Sent: 8/03/2019 11:36:08 AM
Subject: Objection to 267-269 Condamine Street, Manly Vale (DA2019/0114)
Attachments: 190306 - Tomasy - Objection to D2019-0114.pdf;

Re: OBJECTION TO DEVELOPMENT PROPOSAL (DA2019/1579) at no. 267-269 Condamine Street, Manly Vale

Figure 7: Residential units located at the ground floor level

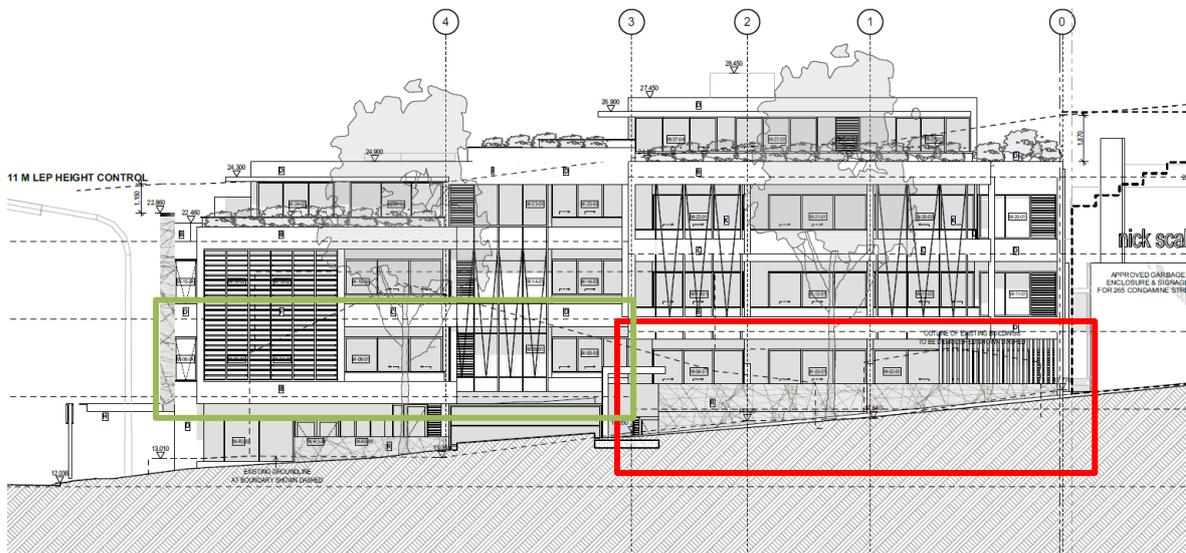
The north-western corner of the proposed development fronting Kenneth Road consists of residential units at the ground floor level and subsequently is inconsistent with the definition of 'shop top housing'. In order to be in keeping within the definition of 'shop-top housing' the ground floor level must be used for the purposes of a retail or business premises and all residential units on that respective level be entirely above the ground level (see box shown red). In addition to the above, the residential units on the eastern block of the building (see box shown in green) must be above the ceiling level of the retail tenancies to ensure that the entirety of the dwellings is above the ground floor retail/business premises.

In accordance with *Hrsto v Canterbury City Council (No 2) [2014] NSWLEC121* the Courts have held that to qualify as 'shop top housing', the relevant parts of the building must be truly above the relevant retail or commercial parts of the building. It is also noted that 'residential accommodation' including 'residential flat buildings' is prohibited within the zone. As the development does not provide 'shop-top housing', the proposal is considered to be an 'innominate' use and is therefore prohibited within the B2 Local Centre Zoning under the WLEP2011.

Figure 4: Building height plane within the streetscape

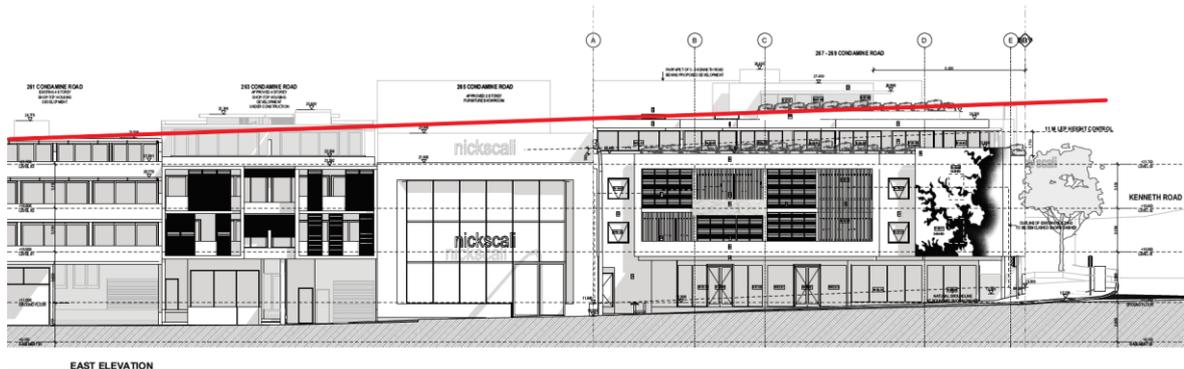
The amended design which incorporates an increased setback from the front building alignment does not reduce the visibility of the upper floor level from the existing streetscape. The subject site is located within a prominent position given it is located on a corner allotment at the intersection of Condamine Street/Kenneth Road and topographically is substantially elevated above the footpath

level due to the significant sloping nature of the site. As a consequence, the site is highly visible from a number of key viewing vistas along the public domain; in particular, the road intersection of Condamine Street and Kenneth Road and any non-compliances to the height and storey control will be intensified. The building separation from the non-compliant upper floor level to the eastern side of the Condamine Street alignment will ensure that the fourth storey will be visible from the street and is appreciable from the existing streetscape setting. A more compliant development which removes the topmost level will represent a more compatible built form that is consistent with the neighbouring buildings within the street. It should be noted that the view impacts of the building are visible from the opposite side of Condamine Street have been neglected within the view analysis and fails to address any potential detracting view elements that may be visible from the street.

Figure 5: The proposed development and the breach to the building height plane

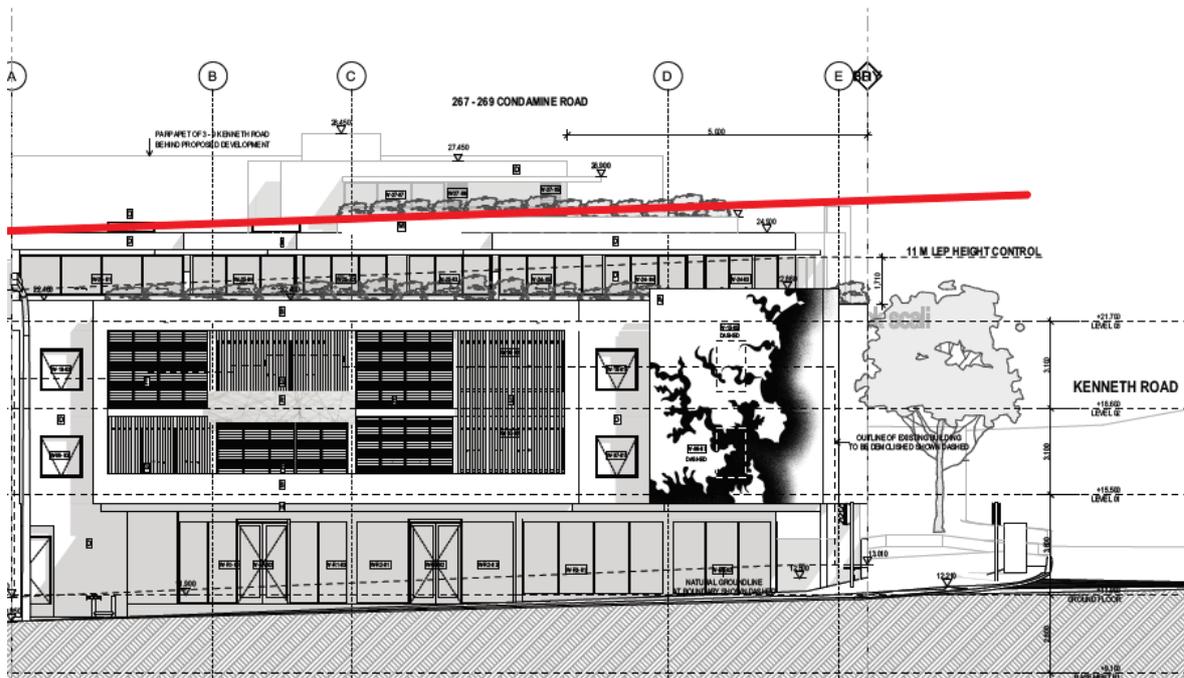
- A. The vertical distance between the ground floor of the existing building (RL12.95) and the lift overrun of the new building to the west is (RL28.45) will result in a building height of 15.5m (36% variation from the maximum building height development standard).
- B. The vertical distance between the ground floor of the existing building (RL12.95) and the roof parapet of the western building block (RL27.45) will result in a building height of 14.5m (32% variation from the maximum building height development standard).
- C. The vertical distance between the ground floor of the existing building (RL12.95) and the roof parapet of the eastern building block (RL24.9) will result in a building height of 11.95m (8.6% variation from the maximum building height development standard).

To ameliorate the apparent bulk and scale of the upper floor level from the previous development application (DA2018/1579), the applicant has reduced the size of the upper floor level on the western building block including an increased setback from the northern property boundary - above the minimum requirement of 5m as prescribed within WDCP2011. While the reconfiguration of the upper floor level represents a minor improvement than the previous development application, the proposal will still contribute to extensive visual bulk and scale when viewed in the context of the neighbouring buildings within the street. The existing streetscape consists of a mixture of 2 – 4 storey shop-top housing developments and commercial developments, all of which fall within a relatively consistent building height plane as measured from the roof parapets of the neighbouring buildings. The non-compliant upper floor level which breaches the maximum permissible building height by 36% will extend beyond the building height plane set by the neighbouring buildings and will not be consistent with the existing built form pattern within the street. The non-compliant fourth floor level on the western building block presents as a fifth storey building element when viewed from the street. The additional storey detracts from the quality of the streetscape in that it creates a disproportionate building height that adds considerable bulk and scale when viewed from the Condamine Street and Kenneth Road.

Figure 6: Non-compliant storey of the proposed development as seen in red.

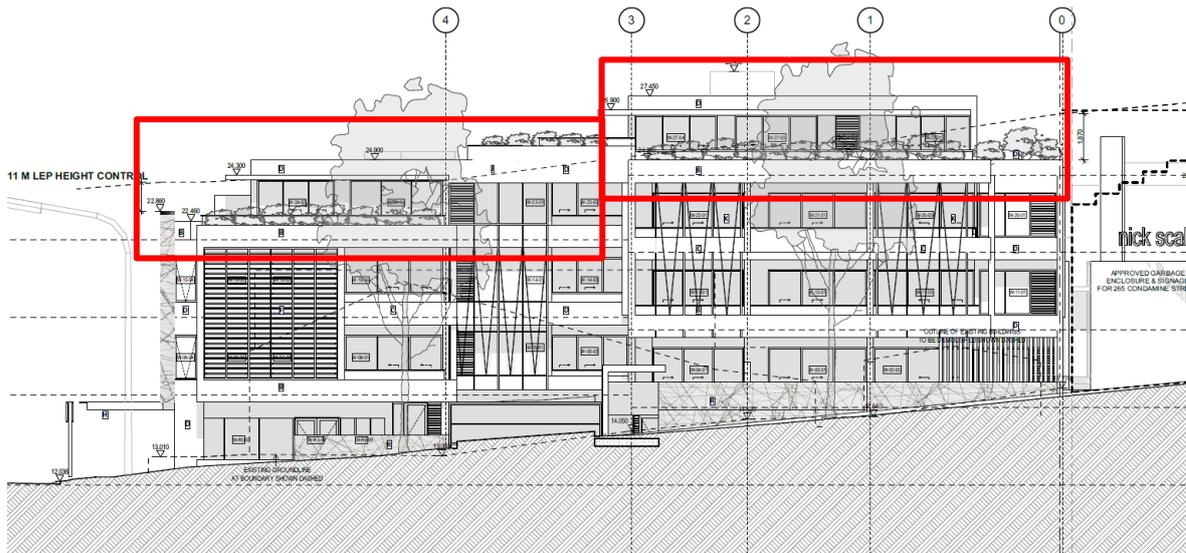
The proposal involves the construction of a four-storey, shop-top housing development which does not comply with the Council’s controls and exceeds the storey requirement by one level.

The proposed four storey, shop-top housing is a breach to Council's controls which permits a maximum number of three storeys. Any variation from the numerical requirements of the Council controls requires the proposal to demonstrate compliance with the relevant objectives of B2: Number of Storeys within the WDCP2011. The relevant objectives that are applicable to the proposed development are as follows:

While the four-storey building element to the street frontage of Condamine Street will generally be aligned to similar building heights along the street frontages of the neighbouring developments, the upper-most level to the west of the building is visible from the existing streetscape setting in particular from key viewing vistas along the intersection of Condamine Street and Kenneth Road. The additional bulk and scale of the development, which arise from a non-compliant building height, will detract from the quality of the streetscape setting and visually dominate its immediate surroundings. Notwithstanding this, the number of storeys do not correspond with the height of buildings development standard within WLEP2011. The WLEP2011 prescribes a maximum 11 metre building height limit which permits a maximum of three storeys when applying the minimum floor-to-ceiling heights of Apartment Design Guide. The variation from the Council's controls above three storeys is not compatible with the objectives of the WDCP2011 and does not warrant Council support.
